San Francisco Bay Conservation and Development Commission

TO: Design Review Board Members

**SUBJECT: China Basin Park Component of the “Mission Rock” Mixed-Use Development;
Second Post-Permit Issuance Review**
(For Design Review Board consideration June 8, 2020)

Permitted Conceptual Site Plan of China Basin Park

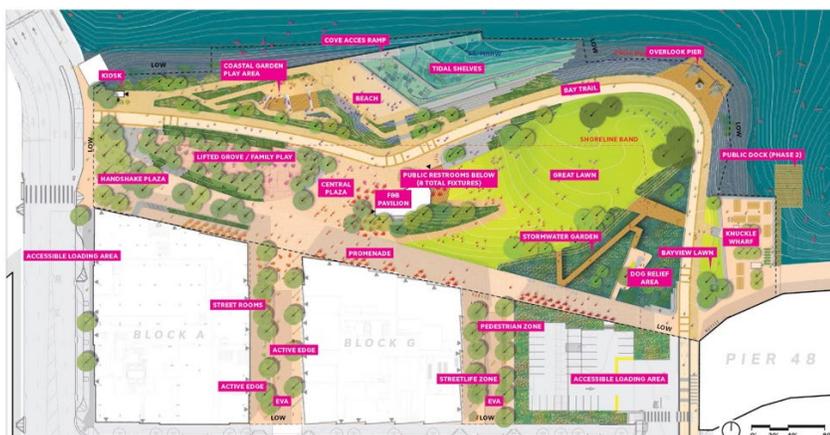
The permitted park project was a preliminary concept design that included the Bay Trail situated prominently along a planted shoreline, a wide promenade along the building frontages, a large flexible use lawn, an entry plaza from third street, a kiosk structure with a bathroom, another flexible field play area, the existing knuckle wharf and a new kayak launch. The revised design introduced additional programs to the park such as the beach, tidal shelves, and a dog play area.
